*Response to the*  
***Draft South Dublin County Development Plan  
2022-2028***  
*for*  
***National Vehicle Distribution Ltd  
Baldonnell Baldonnell, Dublin 22, D22 AV20***

***August 2021***

***Airport Planning and Development (APD) Ltd.  
Lancaster House  
16 Moorfield Business Park  
Leeds, West Yorkshire, LS19 7AY  
United Kingdom***

**Figure 3.1: Casement Aerodrome Approach & Take-Off Climb Surfaces as shown on the draft Development Plan Maps**

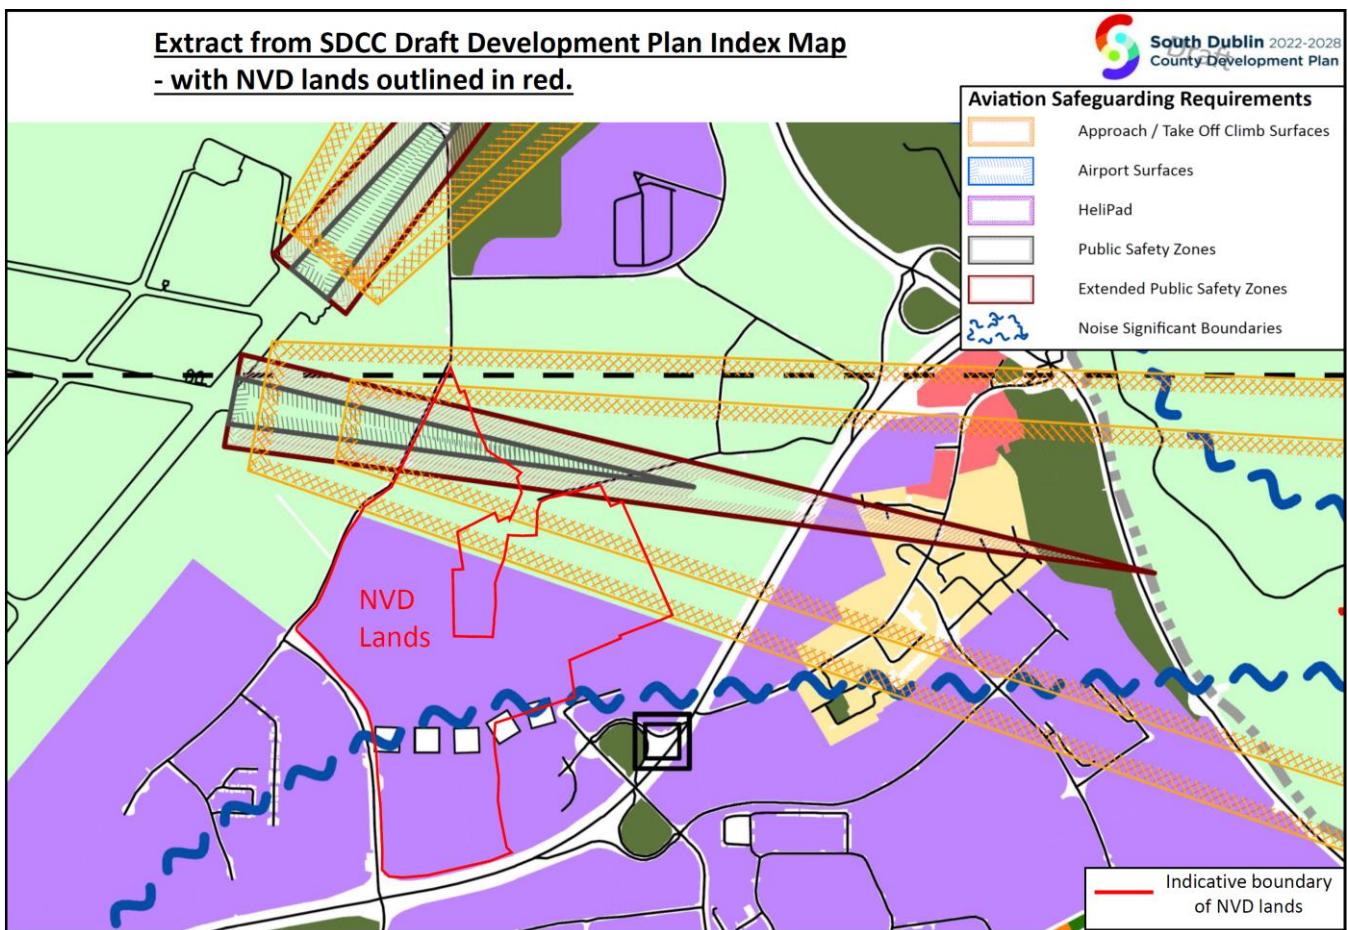
3.4 It is respectfully submitted that SDCC may have misinterpreted the The Development Plan extract (Figure 3.1) is incorrectly drawn in that both the APP and TOC Surfaces illustrates that the Surfaces start from different distances from Runway 28 Threshold; both should be calculated from the same distance of 60m from the runway threshold.

## SDCC Draft Development Plan 2022-28 - Extract from Aviation Safeguarding and Public Safety Zones Technical Guidance Map

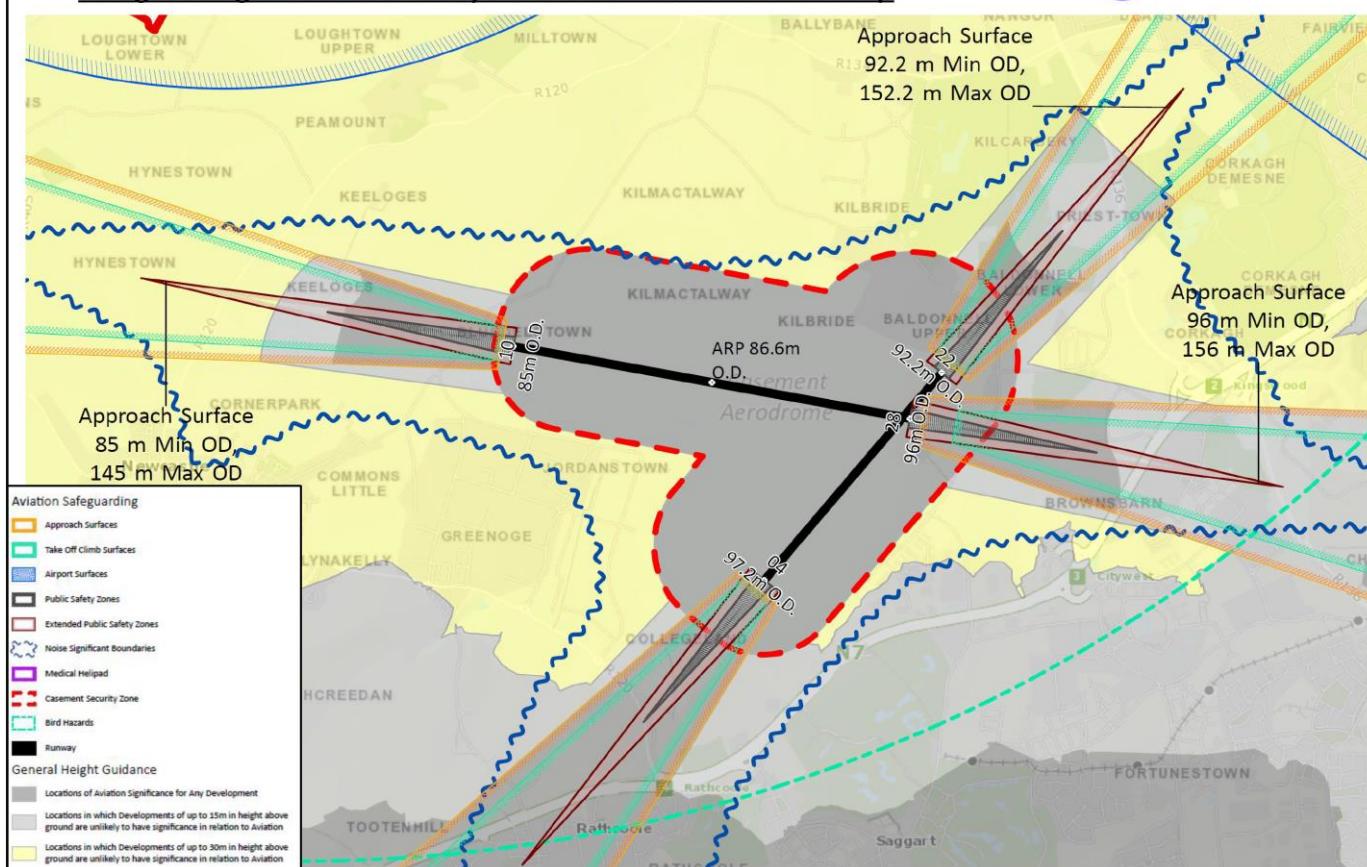
- 3.10 The Aviation Safeguarding and Public Safety Zones Technical Guidance Map indicates in various grey and beige colours some guidance on heights for development. See extract from the Draft SDCC Development Plan map below. Any development of the NVD lands under the APP/TOC surfaces will not interfere with the operations of the aerodrome. Any application for development on such land will include an aerodrome safety assessment.

**Figure 4.1: NVD lands under Casement Aerodrome Runway 28 Approach & Take-Off Climb Surfaces as shown on the draft Development Plan Maps**

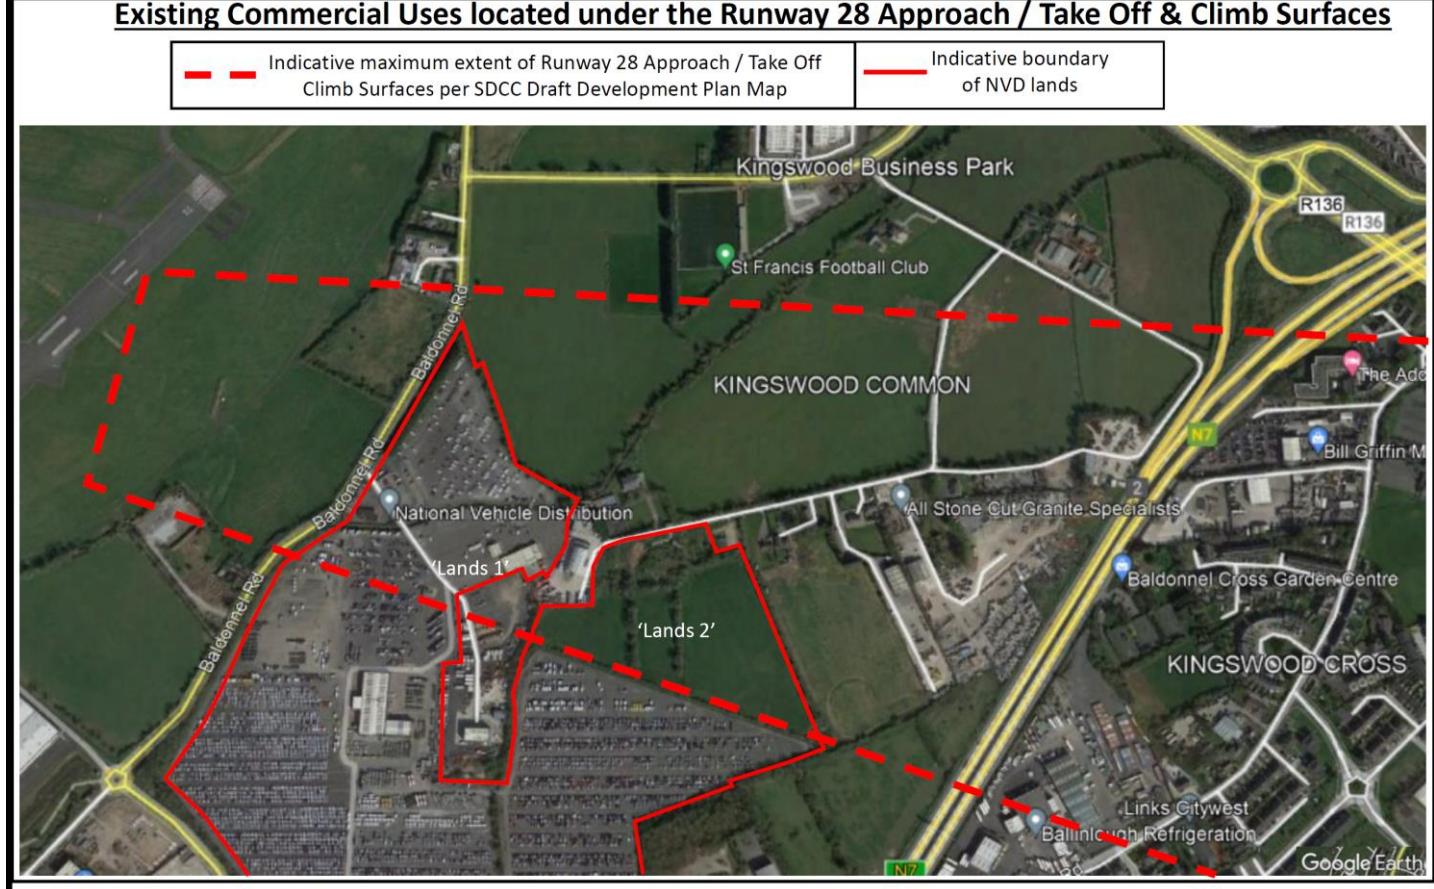
4.1 The NVD facility is a low-rise long established industrial activity involving the long-term storage of vehicles, prior to distribution to dealerships country-wide. A small part of the NVD site, lying below the Runway 28 Approach/Take-Off Climb Surfaces, is used for low intensity commercial development (i.e., car and truck storage) at present, but as the company expands, an increased use for the storage of vehicles is anticipated. It is a very secure and well protected facility, operated by a 'growing' business. It is located in a well-established and expanding industrial area lying to the East of Casement Aerodrome. It is important to note that there is an existing car/truck storage use on the NVD lands closest to the aerodrome boundary under the Runway 28 Approach/Take-Off Climb Surfaces - see Figure 4.1 below.

4.2 Currently, there are a number of premises and residential units located beneath the Approach and Take-Off Climb Surfaces of Runway 28/10 – see Figure 4.1 below.

4.3 The potential impact of increased activity on that part of the greenfield NVD site beneath the APPS/TOCS, and other Obstacle Limitation Surfaces (OLS), and the operation of the aerodrome has been assessed. It is concluded that no part of the NVD facility penetrates any OLS, including the Transitional Surfaces of either runway. In fact, the RWY 28 APP/TOC Slope is well above all existing car storage and low-rise operational buildings. Further, the facility does not generate significant numbers of people on the ground, as there are only a small number of employees, temporarily occupying the site as vehicles are moved in/out of the car/truck storage areas. Therefore, this low occupancy use is compatible with Section 11.7.7 of the SDCC Draft Development Plan.
